ADDENDUM - BAKERSFIELD CITY SCHOOL DISTRICT  
ROOSEVELT SCHOOL MODERNIZATION

ADDENDUM NO: ONE (1)

PROJECT: BAKERSFIELD CITY SCHOOL DISTRICT  
ROOSEVELT SCHOOL MODERNIZATION

ARCHITECT'S  
PROJECT NO: 88-142

ADD  
1-1

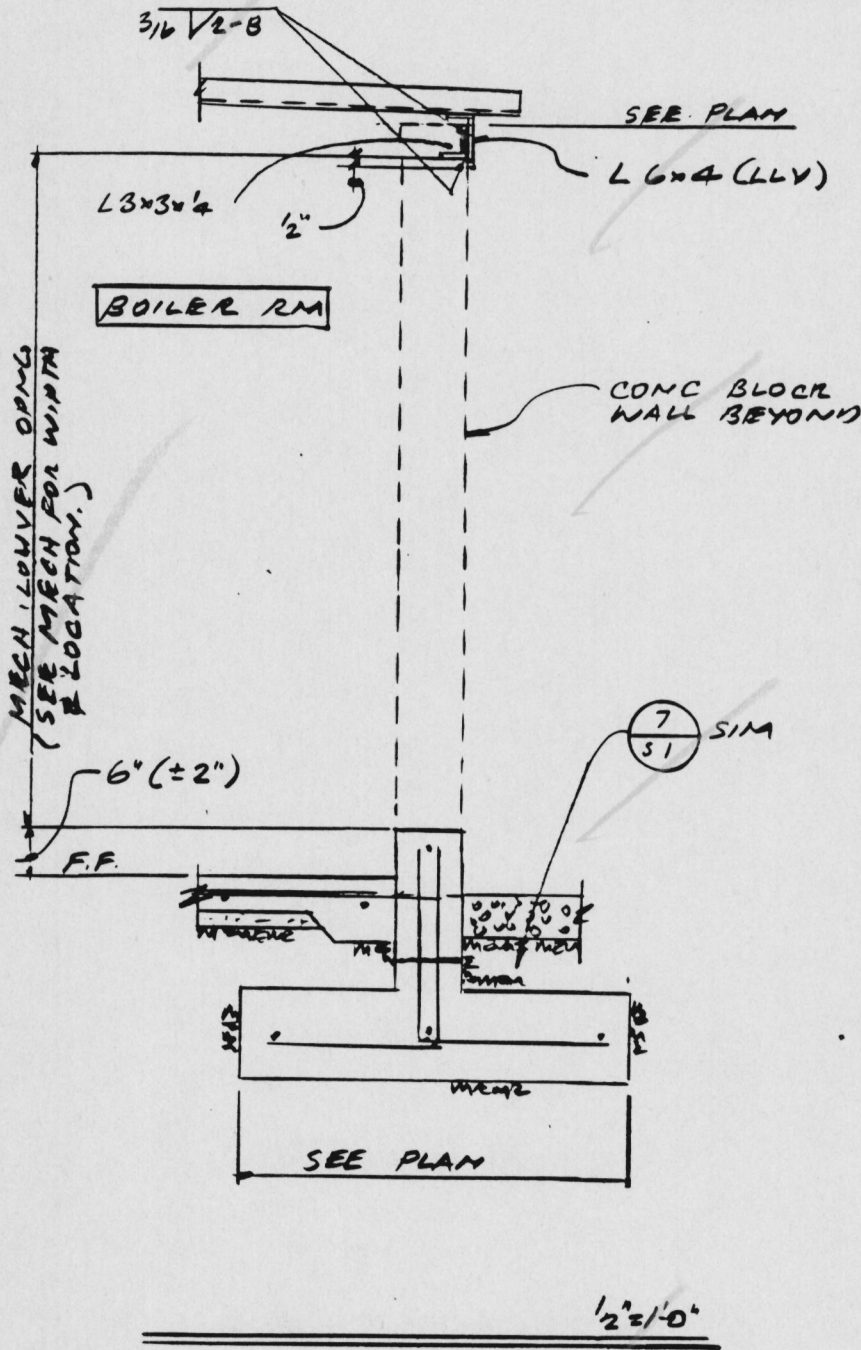
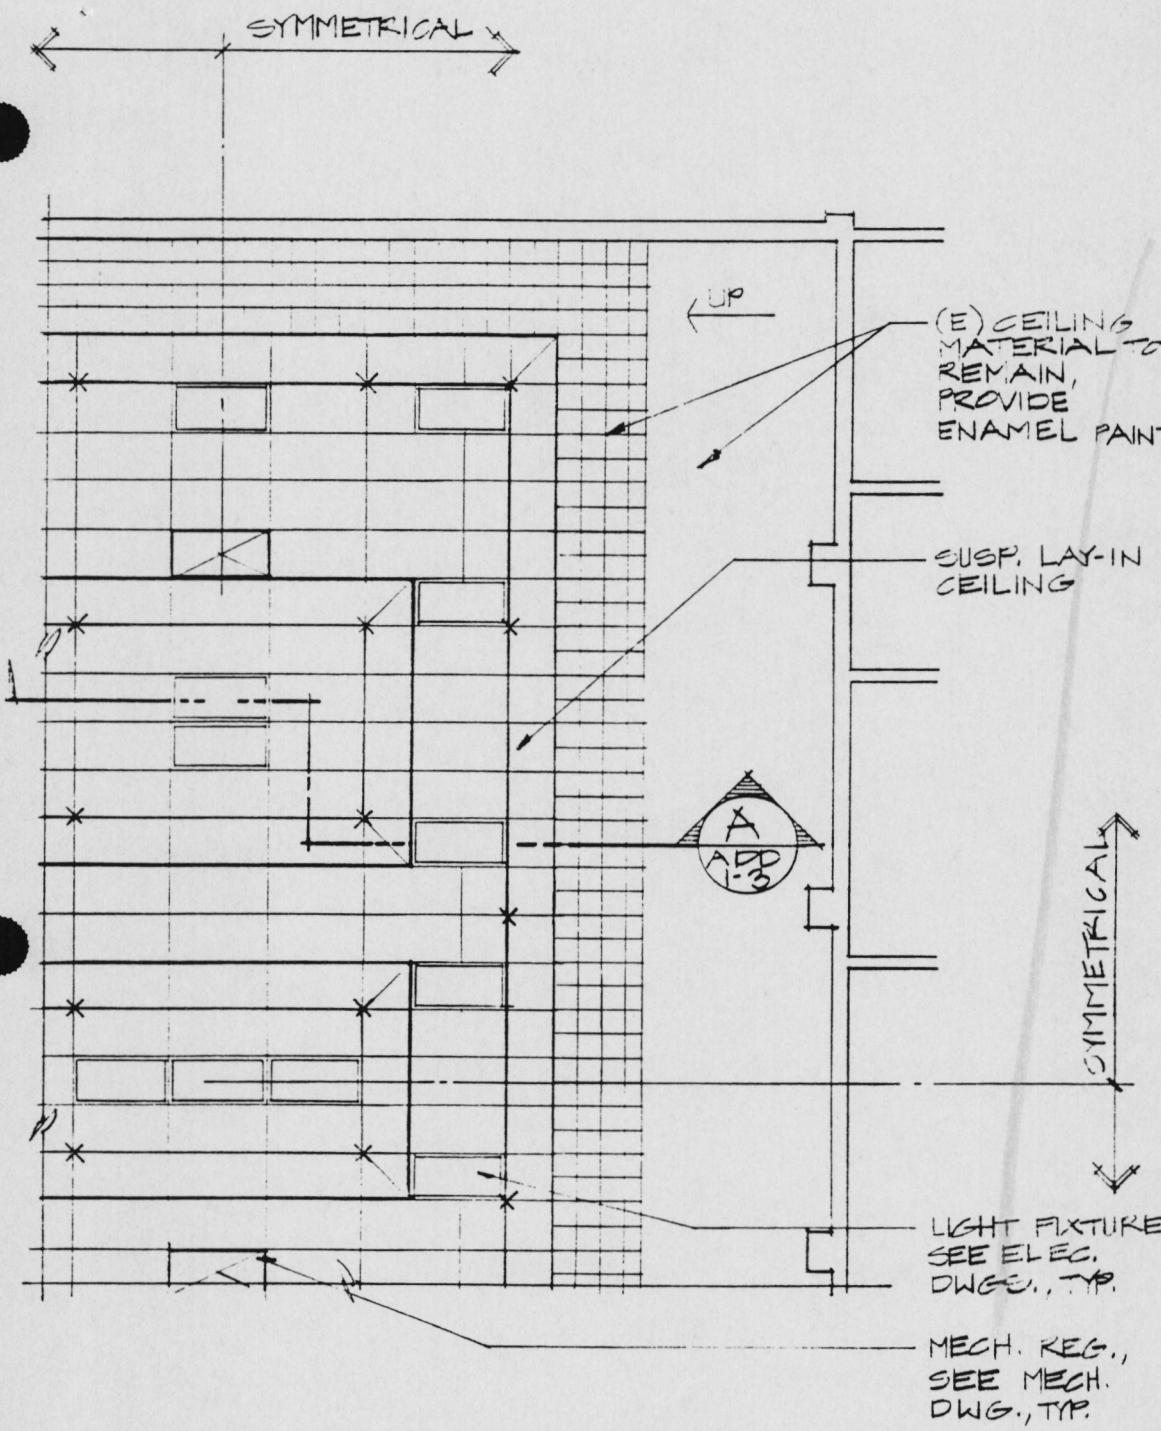
Item (17) Refer to Sheet A1.02 and S2.00, Mechanical/Chiller Yard:

Install louver shown on mechanical sheet M2.00 per attached sketch ADD1-1.

Note: The north edge of the louver shall be 1'-4" south of the wall separating rooms S01 and S03.

ADD  
1-2

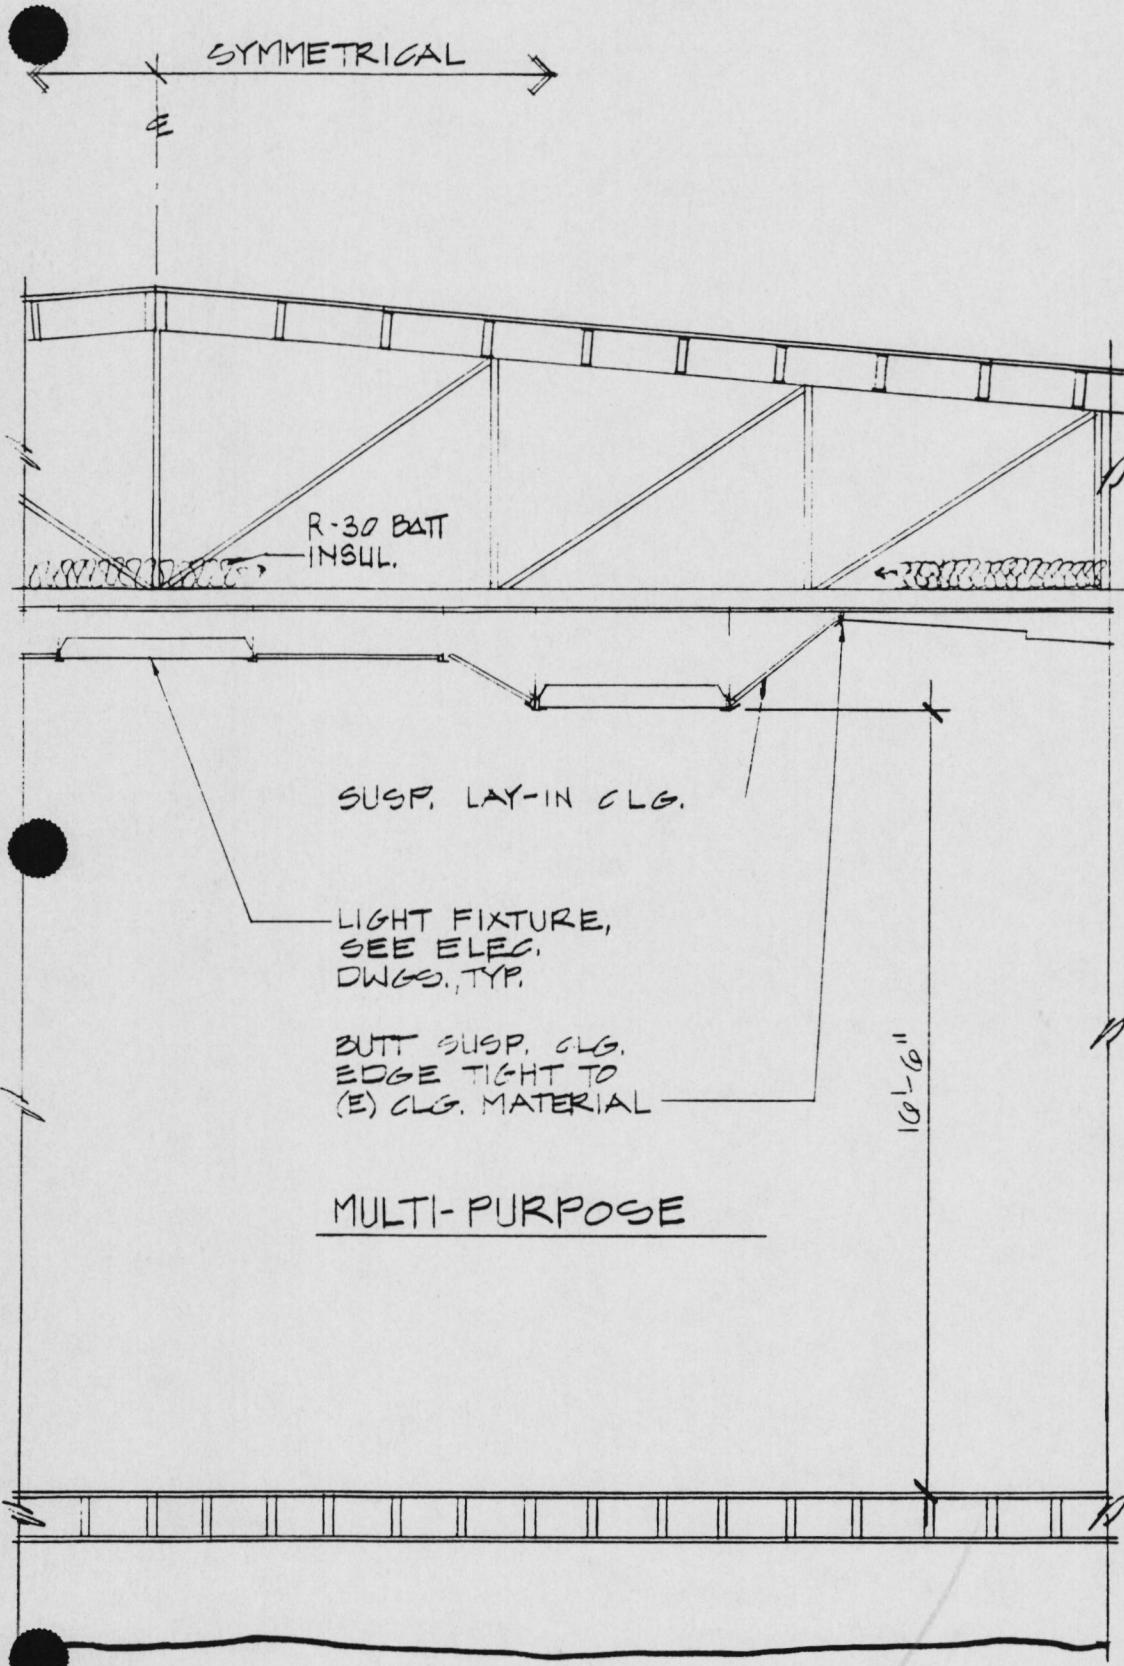
- Item (19) Refer to Sheet A2.01, Building 100 Reflected Ceiling Plan, and Sheet A6.00, Building Section "C";

Note: The Owner's asbestos survey, on file with the School District maintenance office has identified asbestos in the acoustical plaster ceiling in the multi-purpose room 100. To avoid disturbing this material, the new acoustical ceiling layout shall be revised per attached sketches ADD1-2 and ADD1-3. The exact layout for this ceiling shall be field verified with the Architect prior to installation.

Note: The number of lighting fixtures has not been changed in the revised layout.

ADD  
1-4

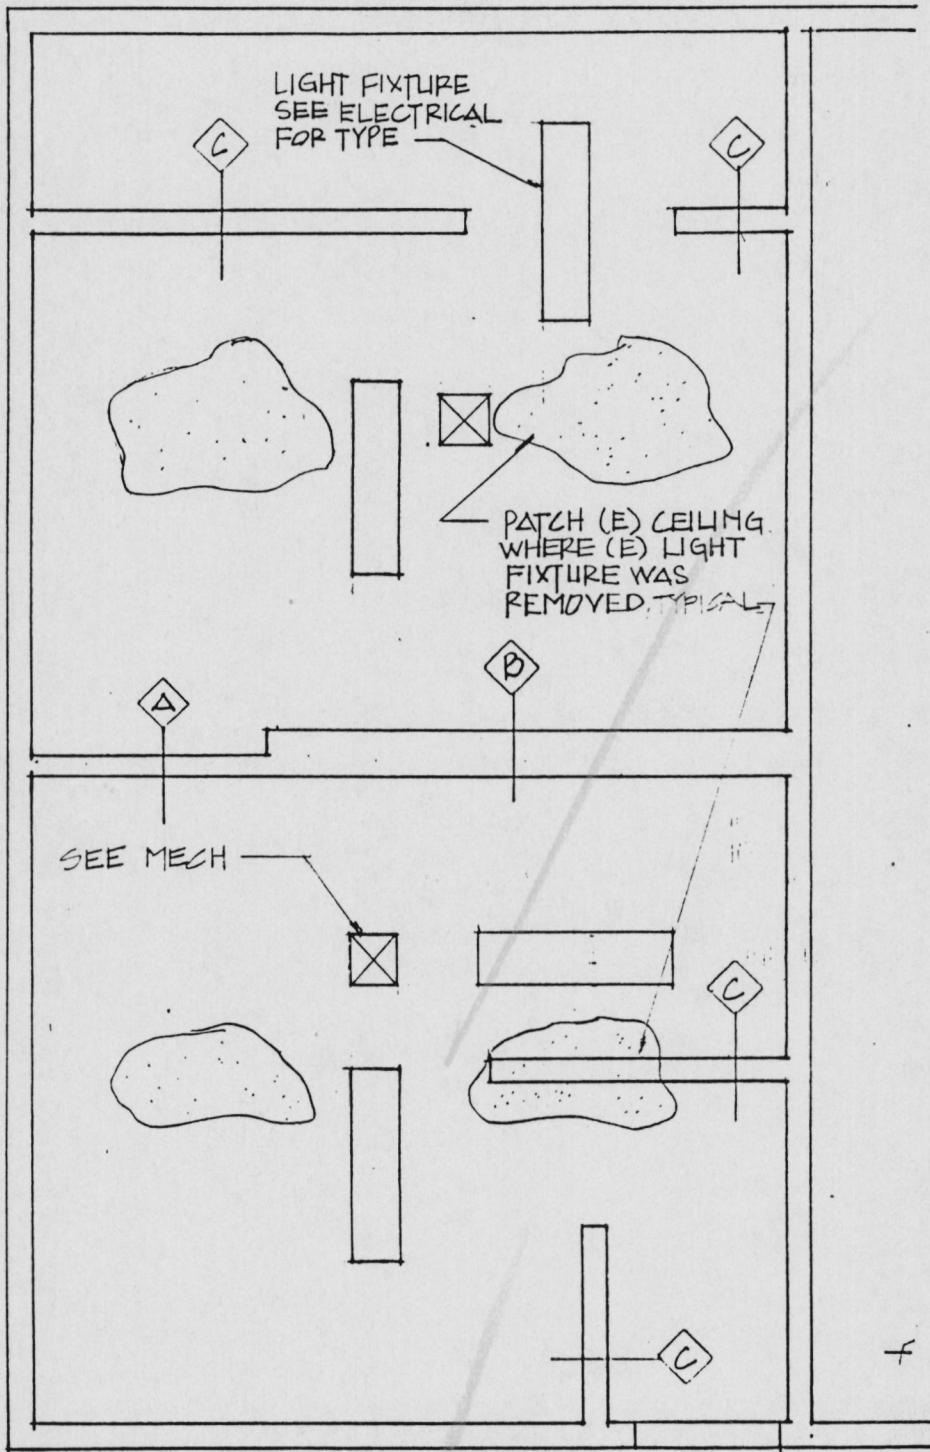
- Item (21) Refer to Sheet A2.01, Detail 5:

Clarification: Attach ceiling hanger and splay wires per attached sketch ADD1-4.

NOTE: SPLAY WIRES PARALLEL TO JOIST.  
SPLAY WIRES CAN NOT BE PERPENDICULAR TO JOIST.

ADD  
 1-5

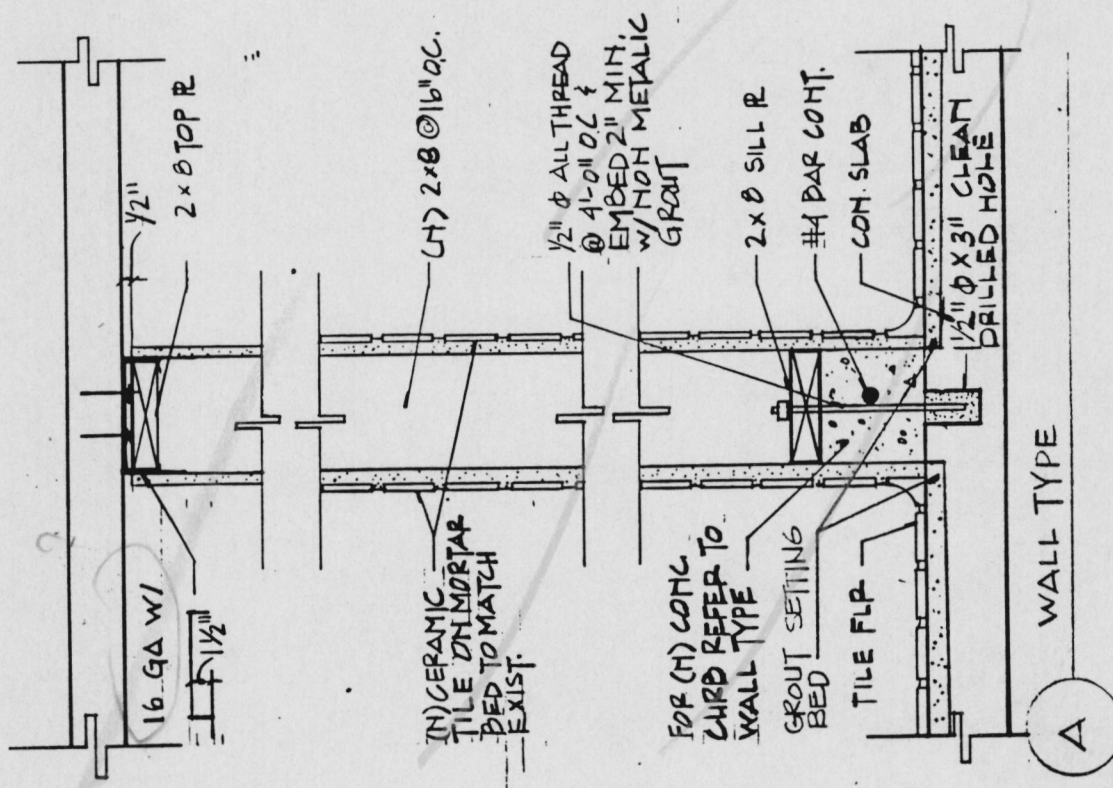
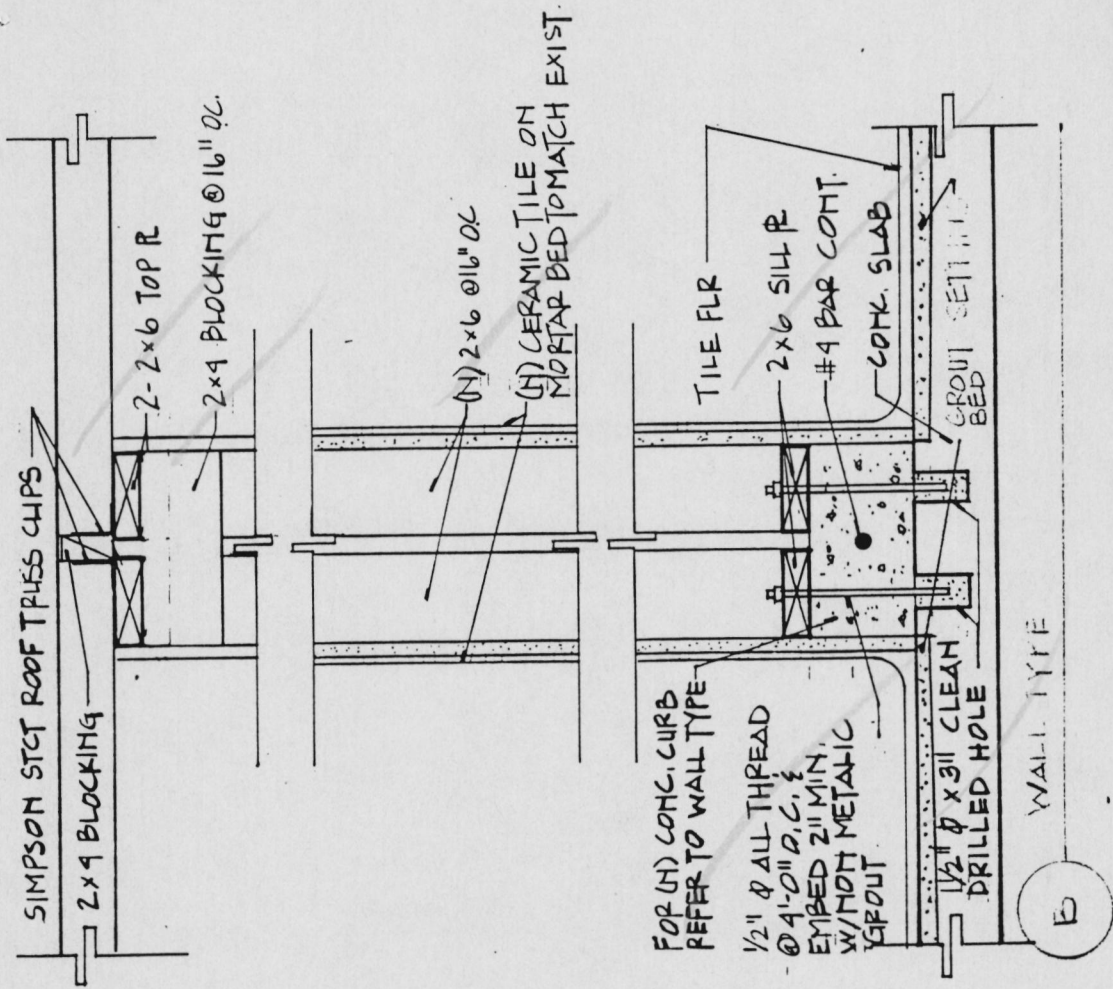
- Item (24) Refer to Sheets A2.04 and A2.05, Reflected Ceiling Plans, Rooms 401, 402, 501 and 502:

Revise Reflected Ceiling Plan per attached sketch ADD1-5.

Note: Wall types for the new walls in these rooms are referenced on attached sketches ADD1-6 and ADD1-7.

JOB NO. 88-142	ADD 1-8
DATE 1.8.191

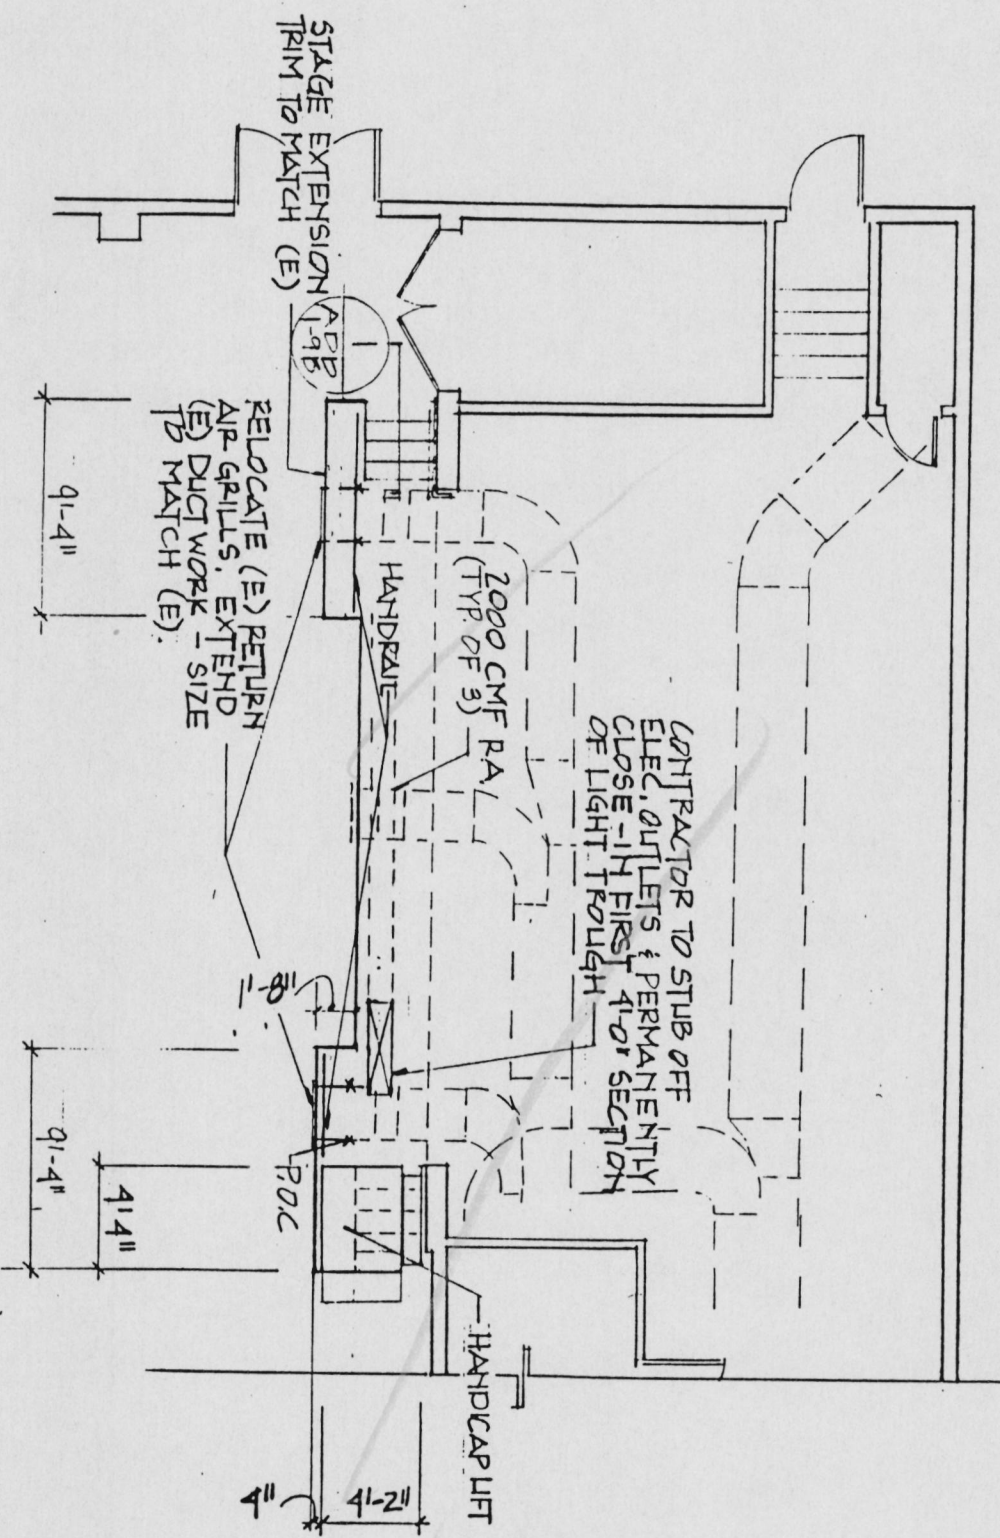
Item (28) Refer to Sheet A3.00, Detail 1:

Revise structural portion at Detail per attached sketch ADD1-8.

REVISE 1 AS SHOWN ABOVE
